REMARKS

Application No. 09/925,961
Amendment dated May 9, 2005
Reply to Office Action dated February 8, 2005

Amendments to the Drawings:

FIG.1

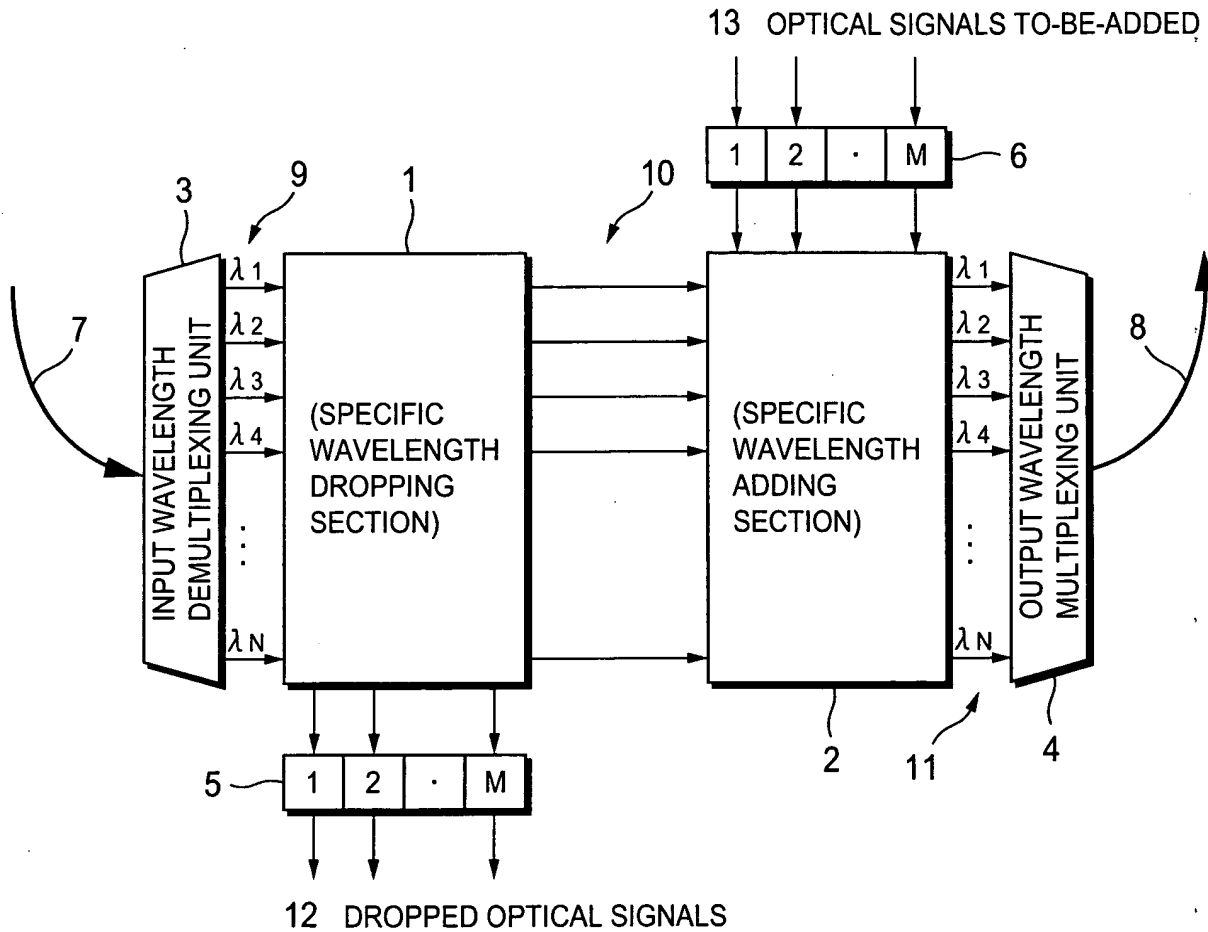
Sheet 1, which includes Fig. 1, replaces the original; sheet 1 including Fig. 1. In Fig. 1 the term "Prior Art" has been added.

FIG.2

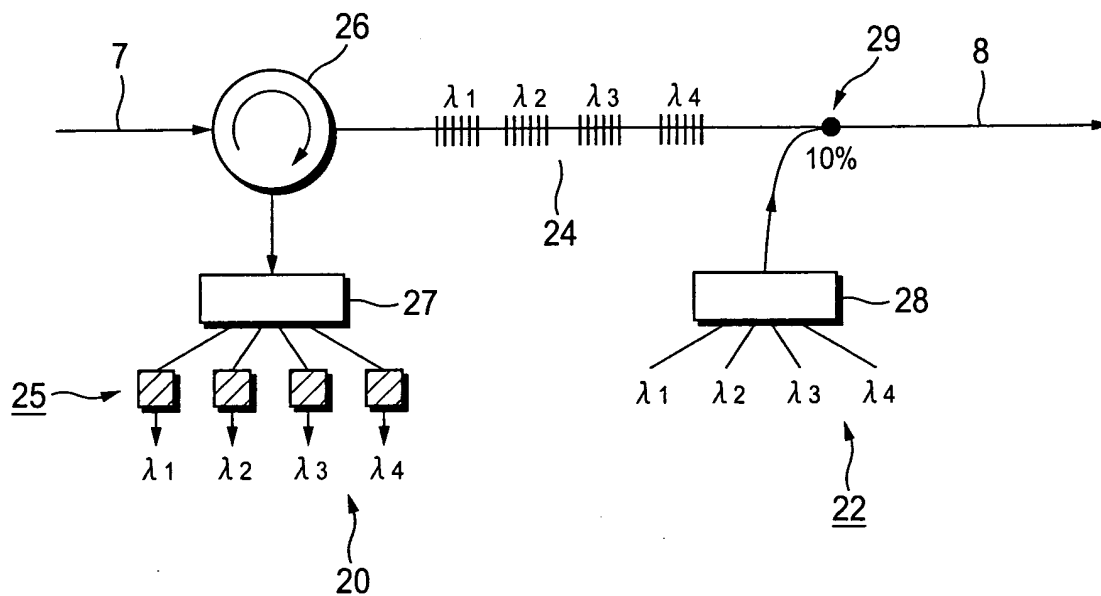
Sheet 2, which includes Fig. 2, replaces the original; sheet 2 including Fig. 2. In Fig. 2, the term "Prior Art" has been added.

FIG.3

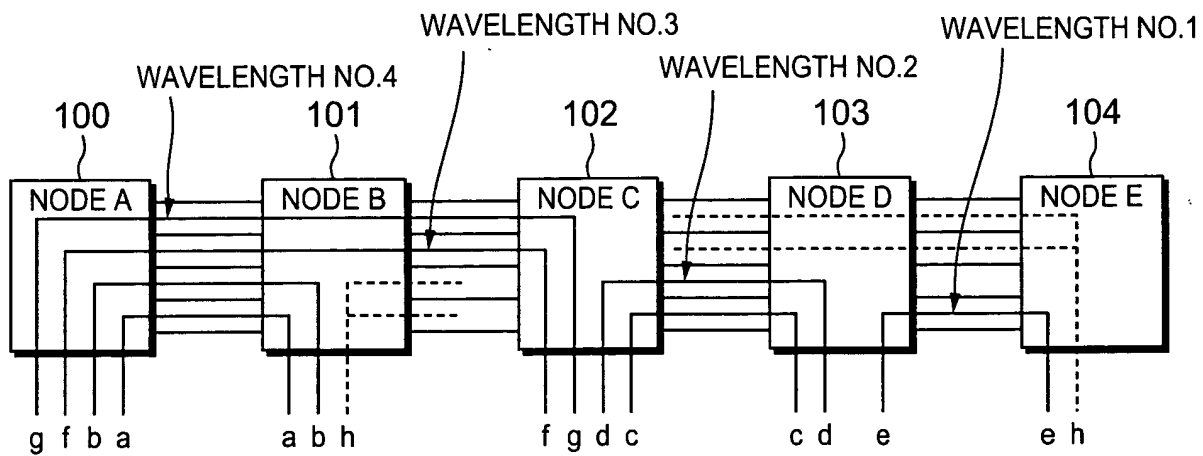
Sheet 3, which includes Figs. 3 and 4, replaces the original; sheet 3 including Figs. 3 and 4. In Fig. 3 the term "Prior Art" has been added.
